Response to Submissions Summary, prepared by Urbis

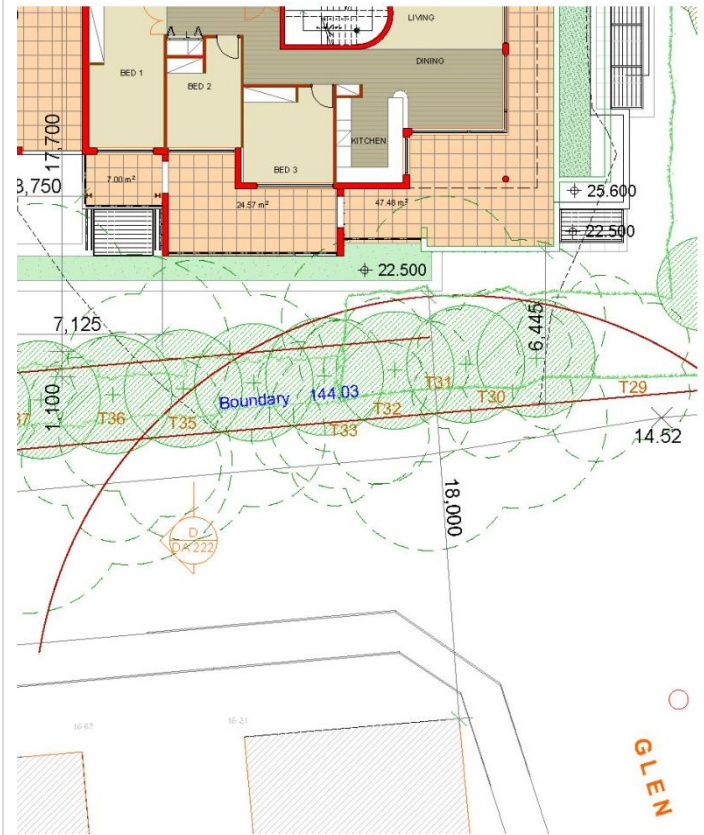
34	Increase setback to Stephen St	26	<p>The proposed setbacks to Stephen Street allow for the various part of the RACF building to step back gradually from the street edge to provide the adequate space for medium to tall vegetation to be planted along the boundary.</p> <p>An increased setback is not necessary in order to augment the separation distance between the proposed RACF and 40 Stephen Street. The required 18m separation distance as per the Residential Flat Design Code is not applicable in this instance as the proposal is not a residential building; it is a commercial facility</p>

and the rule of thumb was envisioned as a guide for buildings on adjoining lots on the same side of the street and not across the road. In any case and as the following diagram shows, the separation between parts of the buildings is already greater than

18m.

While an increase in the set back is not necessary, amendments to

the basement plan have been made to preserve more of the existing trees. Refer to the architectural plans.
35	Relocate air-conditioning units from Stephen st	26	<p>Refer to drawing DA 520 revision A.</p> <p>The air-conditioning condensers to the RACF building have been relocated and are below the level of Stephen Street. The condensers are screened with louvres and landscaping.</p>
36	Retain on street parking in Stephen st	10	<p>The preferred option is to provide site deliveries from Stephen Street. A VPA is currently before Council seeking to re-organise car parking arrangements in Stephen Street to ensure car parking numbers are retained and better located to facilitate ease of traffic movement around the Glen St intersection.</p> <p>Any VPA entered into between Council and the Church will have been reviewed by Council in respect to public benefit and cost. Any widening of Stephen Street to accommodate 90 degree car parking will have been assessed by Council to determine the public benefit of this proposal.</p> <p>Should any consent issued be conditioned to require service access from Brown Street, no change will be made to the on street car parking in Stephen Street.</p>
